BID BULLETIN NO. 1

PROCUREMENT OF THE SUPPLY, INSTALLATION, AND COMMISSIONING OF FOUR (4) X 20TR DIRECT-EXPANSION PACKAGED-TYPE AIR-HANDLING UNITS (AHU) WITH MATCHING TWO (2) AIR-COOLED CONDENSER UNITS (ACCU) FOR EACH AHU AND OTHER MISCELLANEOUS ITEMS TO COMPLETE THE SYSTEM AT THE GROUND FLOOR LEVEL OF THE INDUSTRY AND INVESTMENTS (I & I) BUILDING

(PROJECT REFERENCE NO. MR24-12-166)

GROUND FLOOR LAYOUT
Industry and Investments (I&I) Building

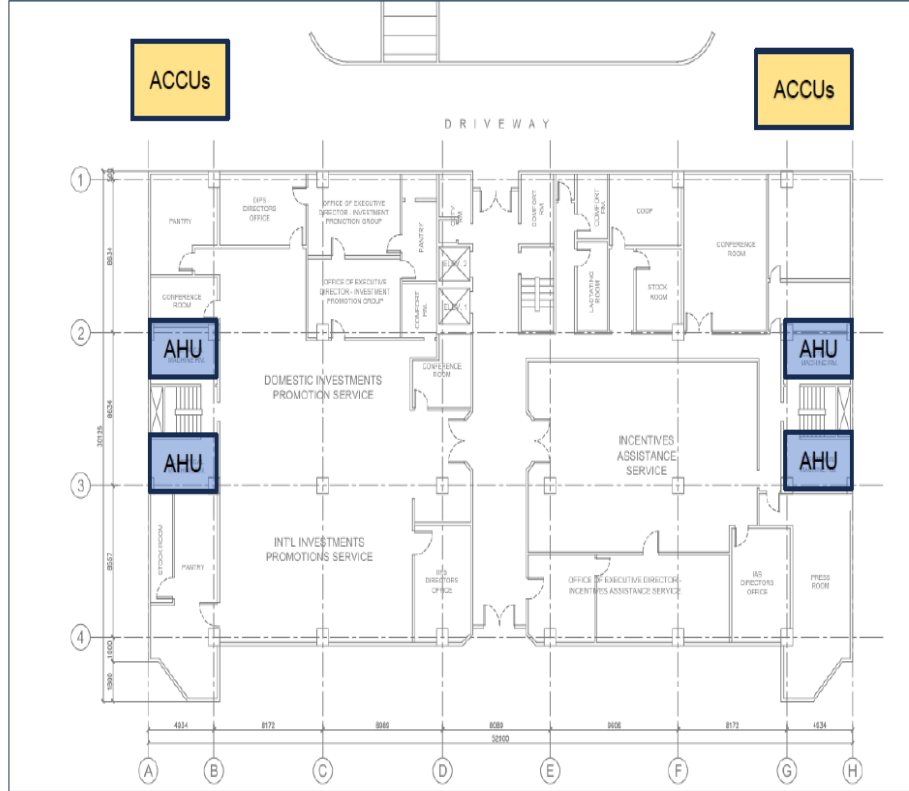
<p>The prospective bidder(s) request a copy of the floor plans or ducting plans for the I & I Building.</p>	<p>Please refer to the attached Ground Floor Layout / key plan, which highlights the locations for the new AHU and ACCU installations.</p> <p>The connection to the existing ducting system, included in the deliverables/BOQ, is the bidder's responsibility to verify and inspect on-site.</p> <p>A site inspection/review is required.</p>
<p>The prospective bidder inquired whether the AHU is intended as a replacement or a new installation.</p> <p>The prospective bidder also inquired about the placement of the old AHU.</p>	<p>The Project requires dismantling of old units and its accessories, and replace with NEW AHUs with ACCUs.</p> <p>Please note that the hauling of the dismantled units and accessories shall be transferred from the I&I Building to NDC Building at 116 Tordesillas St., Salcedo Village, Makati City.</p> <p>Hence, cost for dismantling shall include provisions of hauling as stated above.</p>
